DEALER BULLETIN

SLR/032/99

TO: ALL LAND ROVER DEALERS

TECHNICAL BULLETINS

PROBLEM:
OIL LEAK FROM CAMSHAFT COVER TO CAMSHAFT CARRIER JOINT

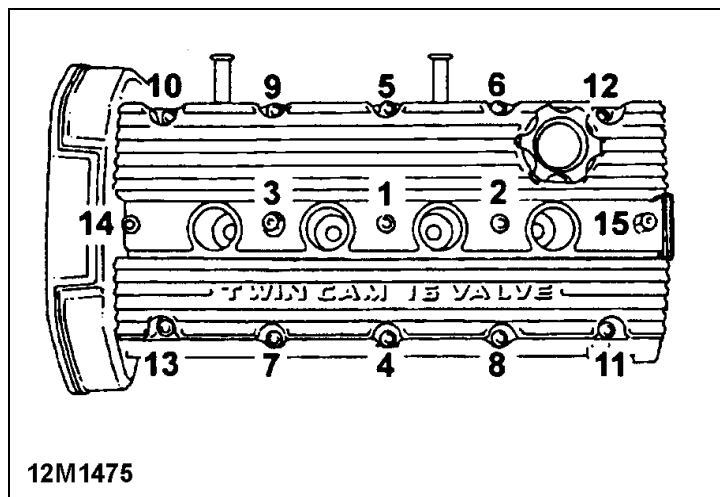
CAUSE:
Loss of clamp load due to relaxation of the gasket material

Where a customer complaint of oil leakage is confirmed to originate from the camshaft cover gasket, replace the gasket with new part LVP100630L.

Ensure that machined faces are not damaged prior to fitting new gasket. Ensure also that camshaft cover to carrier bolts are torqued in the sequence shown in the Workshop Manual and reproduced here.

NOTE: The new camshaft cover gasket LVP100630L can be identified as having a crimped edge unlike previous gasket LVP100260 which was completely flat.

PARTS INFORMATION:
LVP100630L - Camshaft cover gasket

PROBLEM:
'CHECK ENGINE' LIGHT (MIL) ILLUMINATED

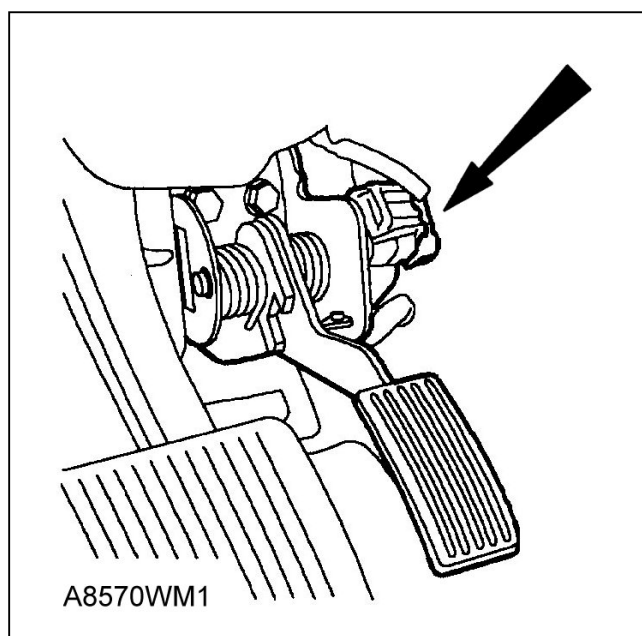
The wiring harness connector may not be fully connected and latched to the throttle position (TP) sensor.

Upon customer complaint of the above problem, confirm that the harness connector is fully latched to the TP sensor.

The sensor, (arrowed in illustration), is an integral part of the throttle pedal assembly.

To confirm that the connector is fully latched, simply push home as far as possible. Visually confirm that the latch has engaged and ensure that the connector cannot now be pulled out.

If the problem persists when it has been confirmed that the connector is secure, run a TestBook HEALTH CHECK in REAL TIME MONITORING to check sensor operation and pedal outputs.

BRAKE LIGHTS INOPERATIVE AND BATTERY LOSES CHARGE WHILE DRIVING

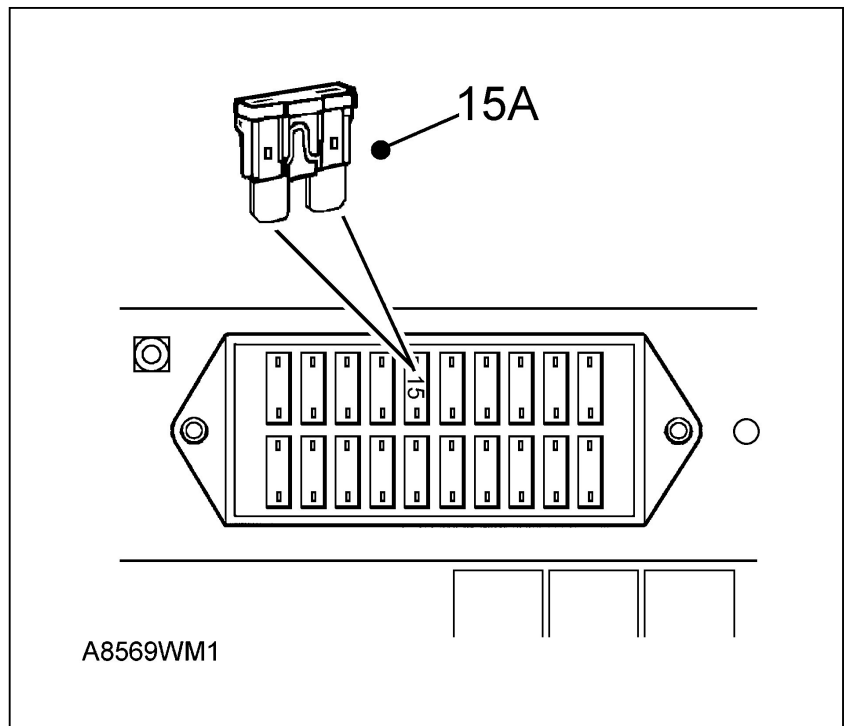
The fuse that protects the stop and reverse lamp circuits has blown, probably as the result of towing a trailer. As this fuse also services the alternator excitation feed the alternator stops charging.

The fuse can blow if the trailer lamps electrical load exceeds 3.5A (2 X 21W bulbs) above normal vehicle load.

Where a customer complaint is traced to the above, to prevent repeat failures replace the existing 10A fuse with a 15A fuse.

NOTE: In no circumstance fit a fuse of greater value than 15A as this may cause permanent damage to the vehicle wiring harness.

The fuse in question is housed in the passenger side fuse box in the location shown in the accompanying illustration.

PARTS INFORMATION:
RTC4503 Fuse – 15Amp
